Amendments to the Drawings:

The attached replacement drawing sheet 3/5 includes changes to Figs. 7C and 7D. This attached sheet of drawings replaces the original sheet 3/5.

REMARKS

FIG.7C

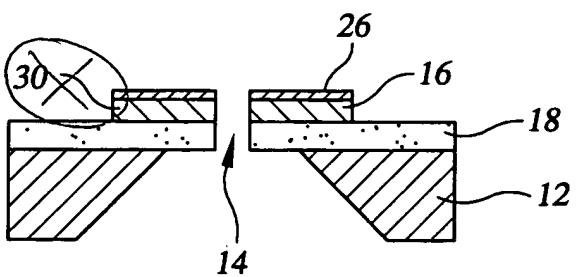
In Fig. 7C, reference numeral “30” has been removed.

Claims 1, 8, 9, 12, and 15 have been amended. Claims 7, 13, 14, and 16-30 have been canceled. New claims 31-33 have been added. In amended Figures 7C-7D, the reference numeral "30" has been removed as it was extraneous and duplicative in identifying the region corresponding to the reference numeral "16." No new matter is added by these amendments to the Claims and Drawings.

Reference
Numeral 30
and lead line
removed
